**CONVENTIONAL ON-SITE WASTEWATER TREATMENT SYSTEM
FINAL INSPECTION FORM**

Project Name and Address
RMC Homes
 9225 Ben Tiran Court
 Lot #98, Filing #2,
 Highland Park Subdivision
 Sch. No. 5232401020
 El Paso County, Colorado

NEW SYSTEM PERMIT - OWTS

**CONVENTIONAL (NON-ENGINEERED)
ON-SITE WASTEWATER TREATMENT SYSTEM (OWTS) DESIGN WORKSHEET
(MUST BE COMPLETED FOR ALL CONVENTIONAL DESIGNS)**

Soil Treatment Area (STA) Layout (Uniformly Pressure Dosed Chamber Beds)

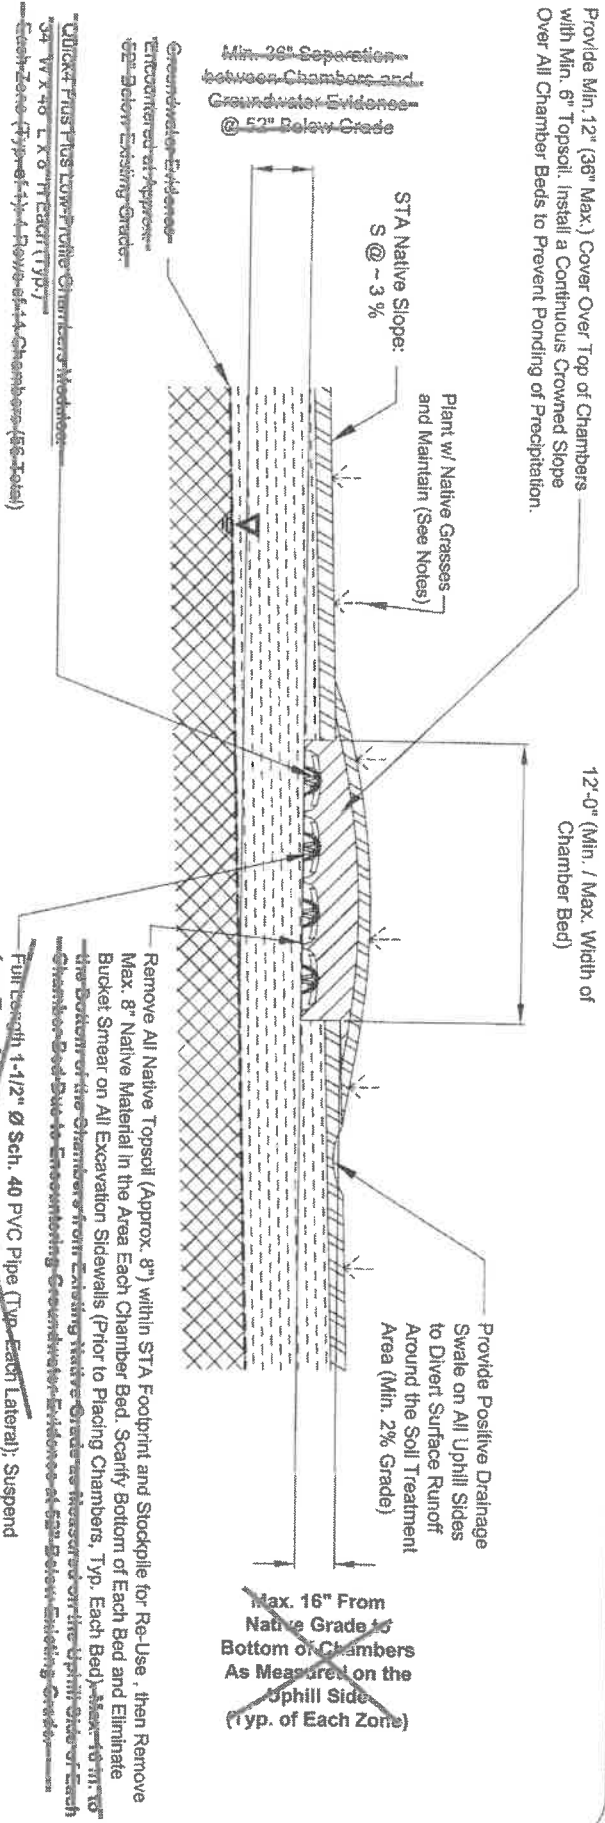
~~Flushing Valve (Typ. Each Lateral, See Detail Below)~~

ARC 36

~~Quick 4 Plus Low-Profile Chambers Modules: 24" x 48" x 36" (Typ.) 16 Each Zone (Typ. of 1); 4 Rows of Chambers (56 Total) 1 row of 6~~

Note: Use of Alternative Chambers is Acceptable. For ARC 36 Low-Profile Chambers (15.0 SF / Chamber, Min. 42 Chambers) Model 4 Zoned, Range of 44 Chambers (Total). Contact Engineer for Clarification.

~~Full Length 1-1/2" Ø Sch. 40 PVC Pipe (Typ. Each Lateral); Suspend from Top of Chamber per Manufacturers Recommendations. Drill 1/8" Ø Holes @ 36" O.C. (Top of Pipe Typ. and Every Third on Bottom).~~

Soil Treatment Area (STA) Cross-Section (Uniformly Pressured Dosed Chamber Beds)

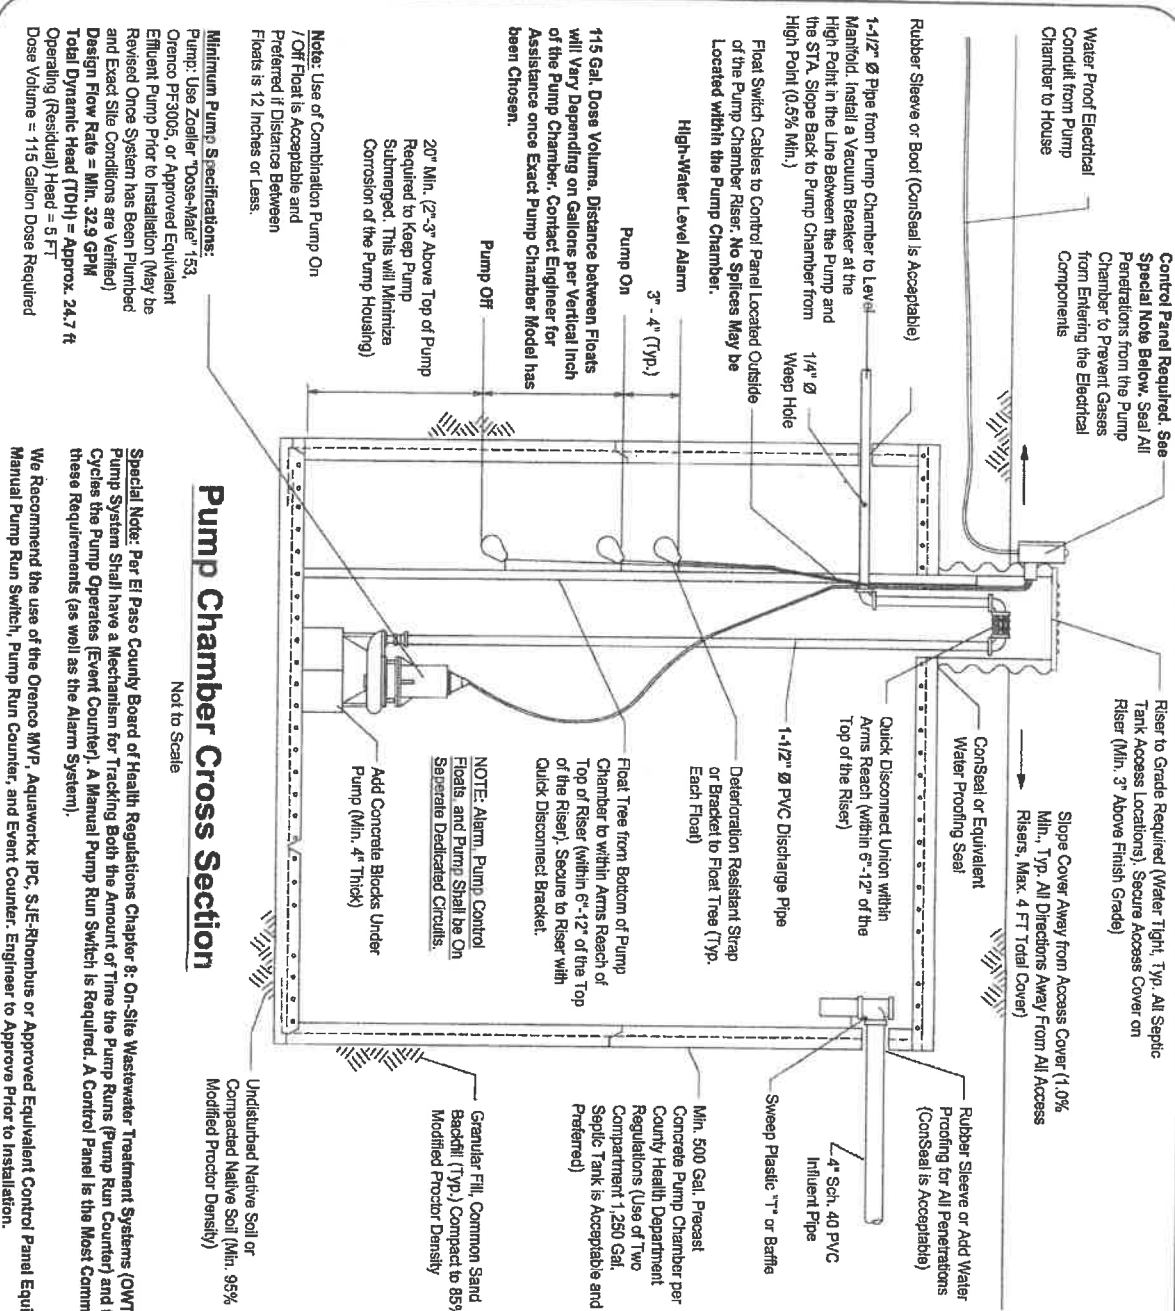
Note: Use of Alternative Chambers is Acceptable. For ARC 36 Low-Profile Chambers (15.0 SF / Chamber, Min. 4.1 Chambers), Install 1 Zone: 4 Rows of 11 Chambers (44 Total), Contact Engineer for Clarification.

70

~~Imported Clean Well Graded Sand/Fill Under Chamber Bed per EPCOD Specifications. Below As Necessary to Maintain Min. 36" to Bedrock and Groundwater Evidence Encountered at 52" Below Native Grade. Sand Should Not be Required if STA is Installed Parallel to Site Contours.~~

~~Remove All Native Topsoil (Approx. 8") within STA Footprint and Stockpile for Re-Use, then Remove Max. 8" Native Material in the Area Each Chamber Bed. Scarify Bottom of Each Bed and Eliminate Bucket Shear on All Excavation Sidewalls (Prior to Placing Chambers, Typ. Each Bed). Measure to 1/16" the Bottom of the Chambers from Existing Native Grade as Necessary on the Uphill Side of Each Chamber Bed due to Encountering Groundwater Evidence at 52" Below Existing Grade.~~

~~Fill to 1-1/2" Sch. 40 PVC Pipe (Typ. Each Lateral). Suspend from Top of Chamber per Manufacturers Recommendations: Drill 1/8" Holes @ 36" O.C. Top of Pipe Typ. and Every Third on Bottom). See STA Layout for Additional Information.~~
